REMARKS

This Amendment is in response to the Office Action mailed 01/27/2005. In the Office Action, the Examiner objected to the drawings and the specification, rejected claims 1-3, 5-12, 14-15, 17-19, and 21 under 35 U.S.C. § 102, and rejected claims 4, 13, 16, and 20 under 35 U.S.C. § 103. Reconsideration in light of the amendments and remarks made herein is respectfully requested.

Appl. No. 10/011,029
Amdt. dated 02/22/2005
Reply to Office Action of 01/27/2005

The attached four sheets of drawings include changes to Figs. 1-4. These sheets, which include Fig. 1-4, replace the original four sheets including Fig. 1-4. Reference numerals have been added.

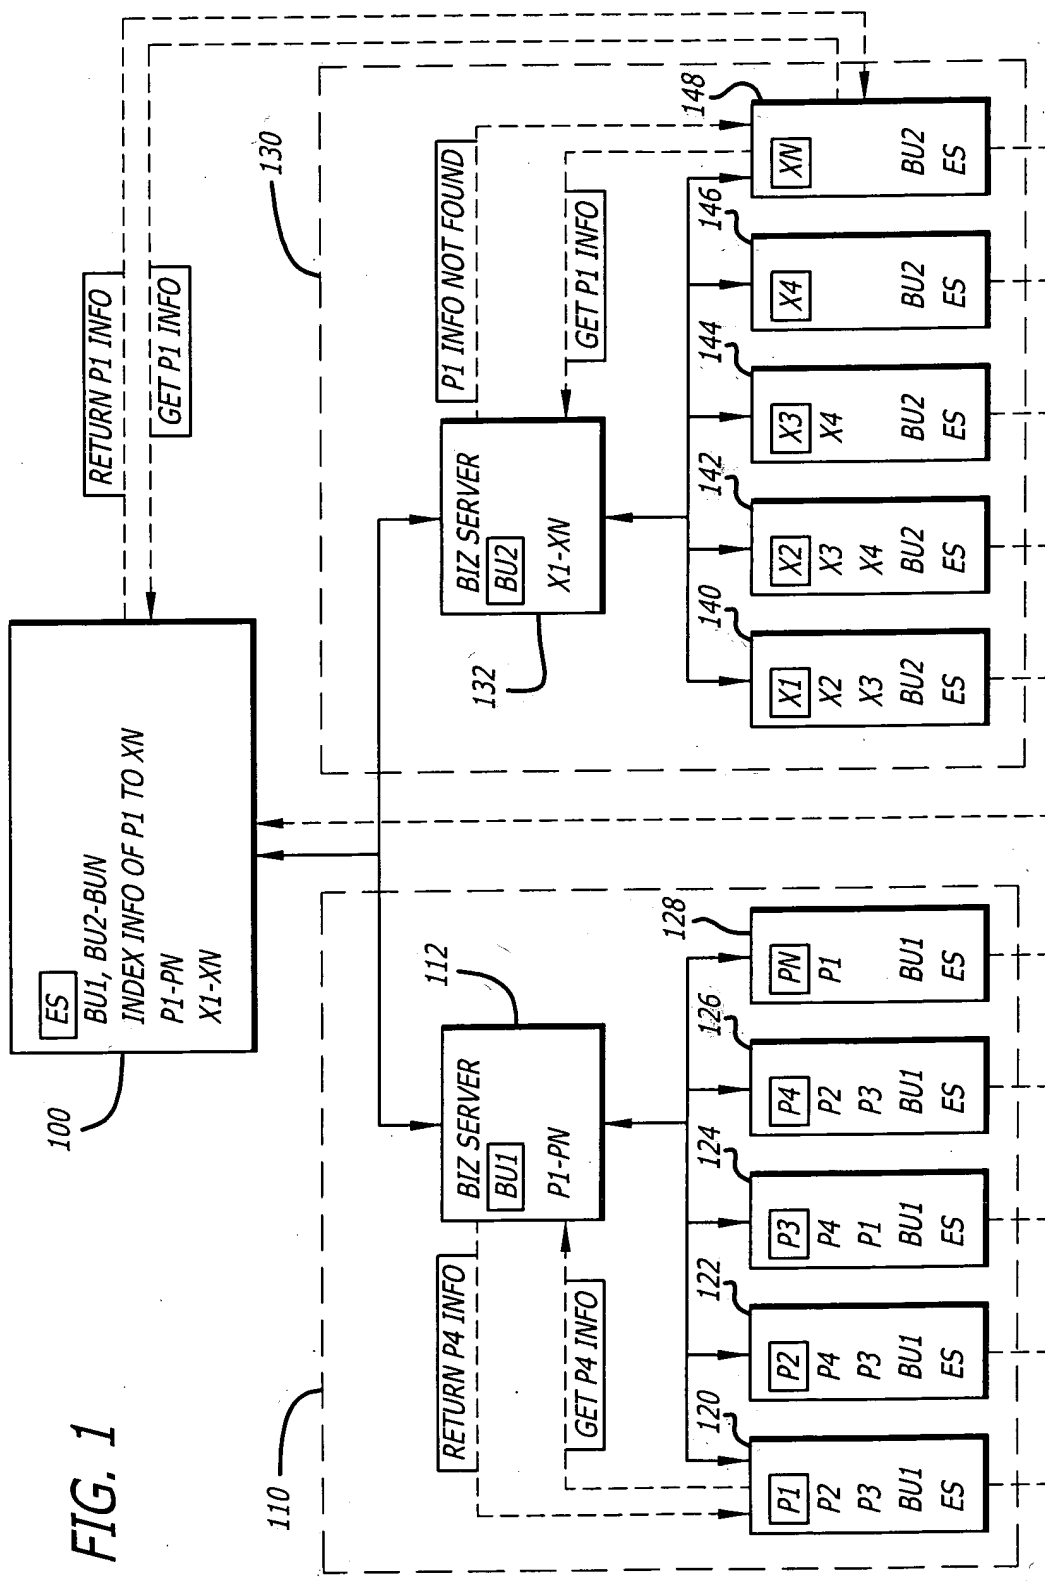
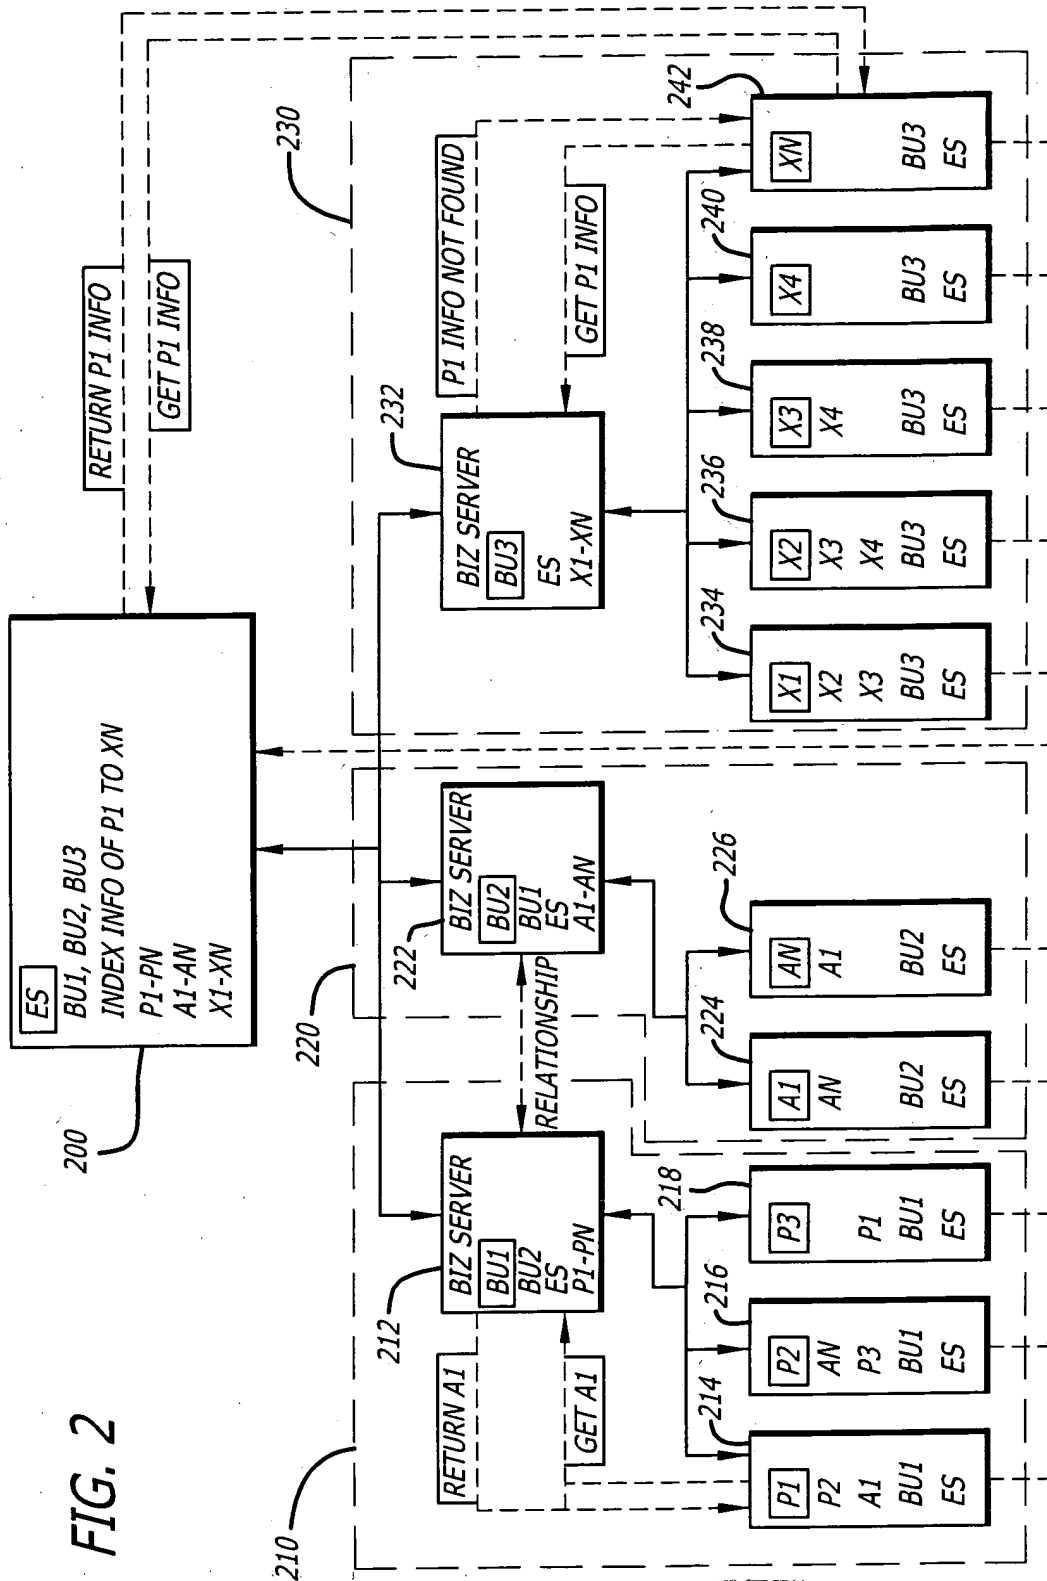
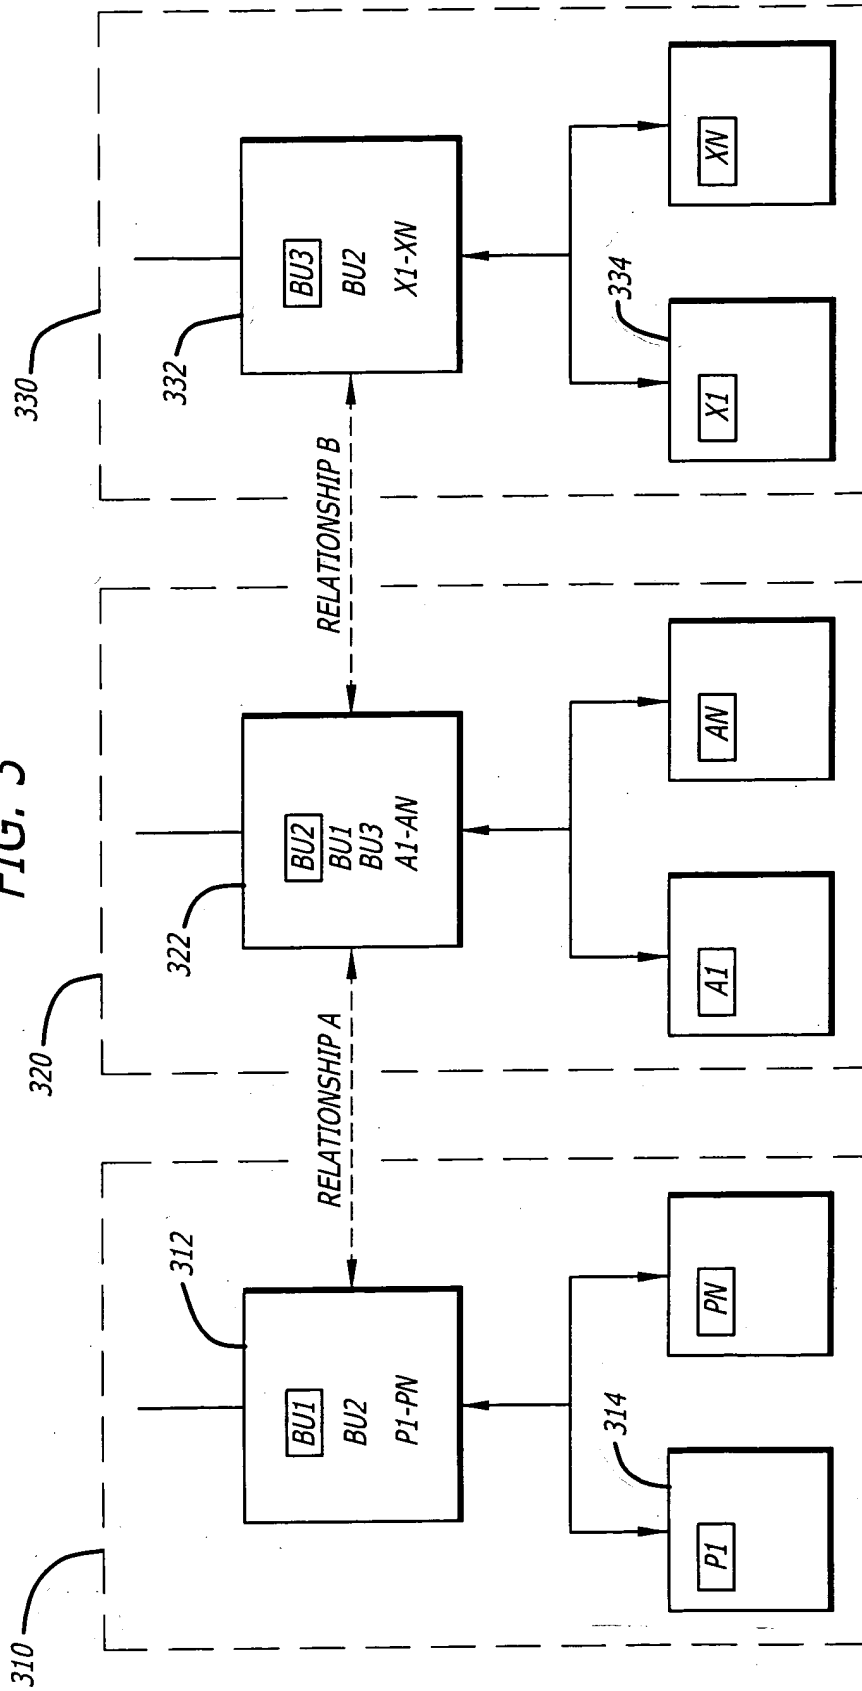
1. The Examiner objects to the drawings as failing to comply with 37 CFR 1.84(p) because the reference characters and their placement within the drawings cause confusion. Applicant has added the preferred numerals for reference characters. The previously supplied indicia, such as "P1", have been retained as textual labels of the blocks in the block diagrams. Applicant respectfully requests that the Examiner withdraw the objection to the drawings.

2. The Examiner objects to the drawings as failing to comply with 37 CFR 1.84(p)(5) because they include reference characters not mentioned in the description. Applicant has added numerals for reference characters. The previously supplied indicia, such as "BIZ SERVER", have been retained as textual labels of the blocks in the block diagrams. With the addition of numeric reference characters applicant respectfully submits that the use of indicia not specifically mentioned in the specification add context and clarity to the figures for the elements which are discussed. Applicant respectfully requests that the Examiner withdraw the objection to the drawings.

3. The Examiner objects to the drawings as failing to comply with 37 CFR 1.84(p)(5) because they do not include reference characters mentioned in the description. The Examiner provides the example of "BU" on page 5, line 32, of the specification. Applicant has amended the specification to replace "BU" with --BU1--. Applicant believes that any other inconsistencies of this type have been addressed by the addition of numeric reference characters. Applicant respectfully requests that the Examiner withdraw the objection to the drawings.
